Heart of Hills IF- ADA Evaluation

IF- Mountain Home TX, Heart of Hills ADA Evaluatio
5103 Junction Hwy
Mountain Home, TX 78058
Accessibility Evaluation
Inspection Date: 03/06/2023
Inspectors: Christopher Meza

Report Date: 02/01/2024

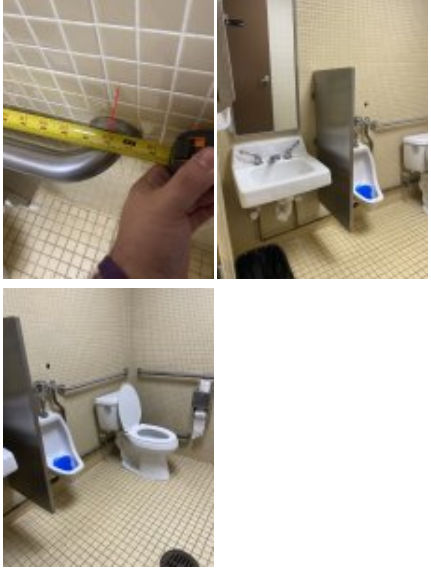
Finding Number	Area Description	Finding	As Built	Recommendation	Citation	Photos	Figure
12	Exterior of Property (Public): Pathway to Holding Ponds - TOUR	The accessible route contains loose gravel and/or surface materials that do not provide for a stable, firm slip resistant surface. Floor and ground surfaces shall be stable, firm, and slip resistant.	The accessible route to holding pond is not compliant due to loose gravel and gravel size. Phasing as smart practice (9) since trails have dual purpose	https://www.access-board.gov/ada/#ada-302_1	2012 TAS Section: 302.1 2010 ADAS Section: 302.1 2015 ABAAS Section: 302.1

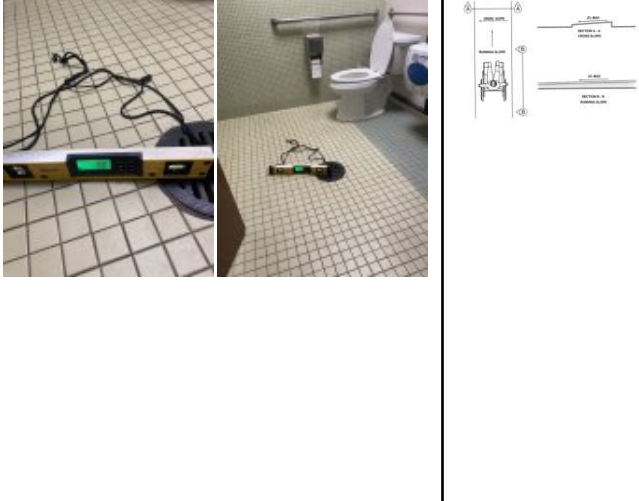
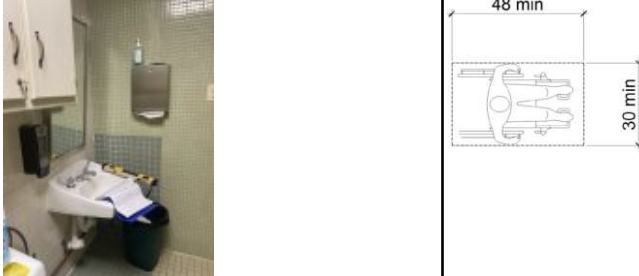
Finding Number	Area Description	Finding	As Built	Recommendation	Citation	Photos	Figure
16	Structures on Property (Public) - Tour/Public Componets : HQ Building/Public Restrooms (Interior) - Restroom (Men's) Public/Staff	The side grab bar does not extend far enough from the rear wall. The side grab bar must extend at least 54 inches minimum beyond the rear wall and start a maximum of 12 inches from the rear wall. A 42 inch grab bar installed the maximum distance from the rear wall (12 inches) will leave the leading end 54 inches from the rear wall. Grab bars shall be installed in a horizontal position, 33 inches minimum and 36 inches maximum above the finish floor measured to the top of the gripping surface.	Measures at 47"	https://www.access-board.gov/ada/#ada-604_5_1	2012 TAS Section: 604.5.1 2010 ADAS Section: 604.5.1 2015 ABAAS Section: 604.5.1		
17	Structures on Property (Public) - Tour/Public Componets : HQ Building/Public Restrooms (Interior) - Restroom (Men's) Public/Staff	The restroom contains storage items and/or supplies which obstruct the clear floor and/or turning space within the restroom. A clear space measured from the floor to a height of 27 inches above the floor, within the restroom, of sufficient size to inscribe a circle with a diameter not less than 60 inches in size or a "T" turning space must be provided.	Storage shelf impedes clear floor space for toilet.	https://www.access-board.gov/ada/#ada-603_2_1	2012 TAS Section: 603.2.1 2010 ADAS Section: 603.2.1 2015 ABAAS Section: 603.2.1 , 803.2, 805.2

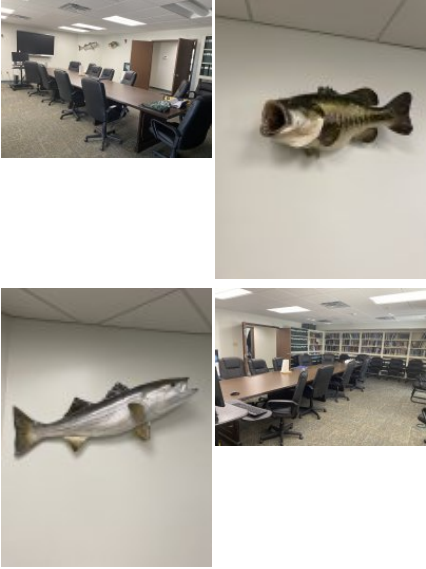
Finding Number	Area Description	Finding	As Built	Recommendation	Citation	Photos	Figure
30	Structures on Property (Public) - Tour/Public Componets : Holding Tanks (Interior) - TOUR - Entrance Doors	The building entrance is not located on an accessible route. When a building, or portion of a building, is required to be accessible, an accessible route of travel shall be provided to all portions of the building, to accessible building entrances and between the building and the public way. At least one accessible route within the boundary of the site must be provided from public transportation stops, accessible parking and accessible passenger loading zones and public streets or sidewalks to the accessible building entrance they serve. The accessible route shall, to the maximum extent feasible, coincide with the route for the general public. At least one accessible route shall connect accessible buildings, facilities, elements and spaces that are on the same site. At least one accessible route shall connect accessible building or facility entrances with all accessible spaces and elements.	There is no accessible entrance into holding tanks for tour. This building exterior and interior are not accessible.	Provide a reasonable modification to allow tour participants an equitable experience during this part of tour.	2012 TAS Section: 206.2.1 2010 ADAS Section: 206.2.1 2015 ABAAS Section: F206.2.1

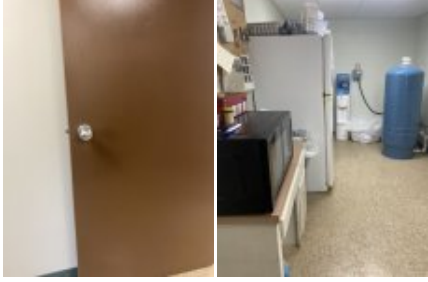
Finding Number	Area Description	Finding	As Built	Recommendation	Citation	Photos	Figure
31	Outdoor Features (Public) : Trials - Birding	The surface of the trails, passing spaces, and/or resting intervals is not firm and stable. The surface of trails, passing spaces, and resting intervals shall be firm and stable	Trails are not compliant with surfacing type, and gravel size requirements. These are used by public to bird watch. Open to public on wed only 8-4 These trails also serve as routes around holding ponds.	N/A - Refer to Finding	2015 ABAAS Section: 1017.2		
32	Outdoor Features (Public) : Trials - Birding - Trails- Birding Sign In Kiosk	The element is not accessible because it does not allow a forward or side approach. This element must be on an accessible route of travel that is 36 inches wide minimum and provides a 30 inch by 48 inch clear floor space that allows a side or forward approach.	There is no way to access this element due to no ADA parking or compliant pathway provided to kiosk. Kiosk used for visitors to sign in when using birding trails.	https://www.access-board.gov/ada/#ada-305_5	2012 TAS Section: 305.5 2010 ADAS Section: 305.5 2015 ABAAS Section: 305.5
